N5541A-01-S

S E R V I C E N O T E

N2X (Router Tester 900) Chassis

Potential power supply failure due to component lead length.

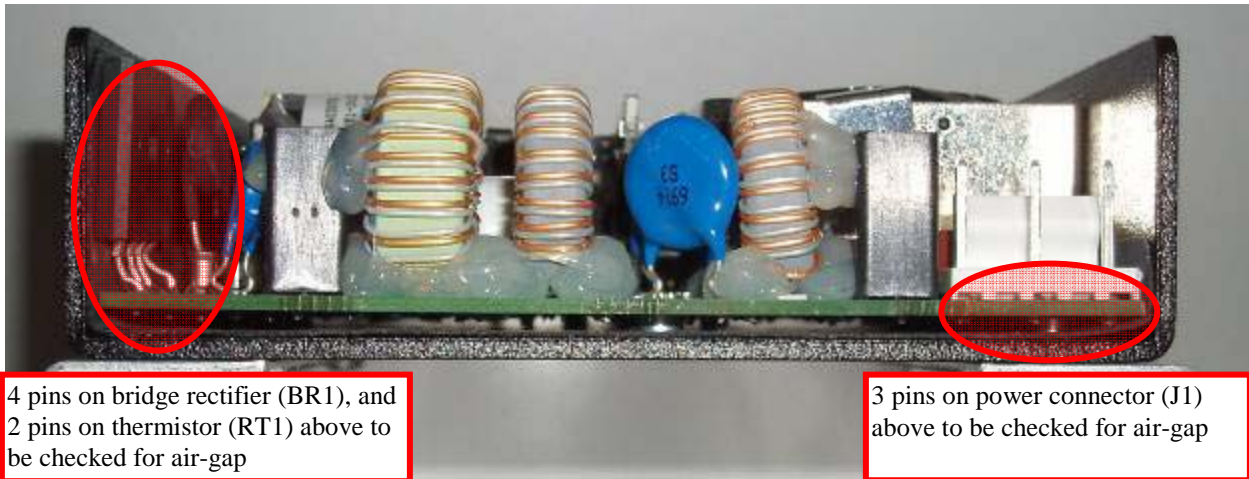
Check the power supply through-hole components as shown below to ensure that there is an air gap between the component leads highlighted and the insulation situated between the metalwork and PCB.

4 pins on bridge rectifier (BR1), and 2 pins on thermistor (RT1) above to be checked for air-gap

3 pins on power connector (J1) above to be checked for air-gap

If there is an air-gap, the power supply can be re-fitted to the chassis and returned to the customer after being tested in accordance with the procedures outlined in the above mentioned service manual.

If there is *not* an air gap, then the power supply should be replaced by a new one – part number E7900-64800 – and the defective one should be returned to SPO for credit return to the division manufacturing organisation.
